Access Compliance Report

Public Rights-of-Way

(Pedestrian Signals)

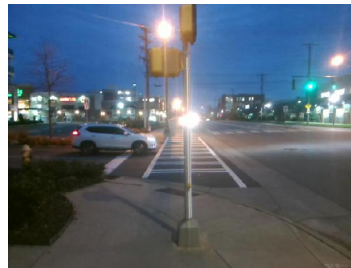
PROW/ADA: R209.1, TMUTCD 4e.08, R404.2, R404.3

Yes	B 1 Clear Xing Direction?	ClearlyMarked	N/A	B 2 Clear Xing Direction?	N/A
	B 1 Crossing Direction	To SE		B 2 Crossing Direction	N/A
Yes	B 1 DistanceTo XWalk (in)	0.0	N/A	B 2 DistanceTo XWalk (in)	N/A
No	B 1 DistanceTo Curb (in)	98.0	N/A	B 2 DistanceTo Curb (in)	N/A
Yes	B 1 Diameter (in)	2.0	N/A	B 2 Diameter (in)	N/A

Possible Solutions: Replace Signal Push Button With APS Button on New Post.
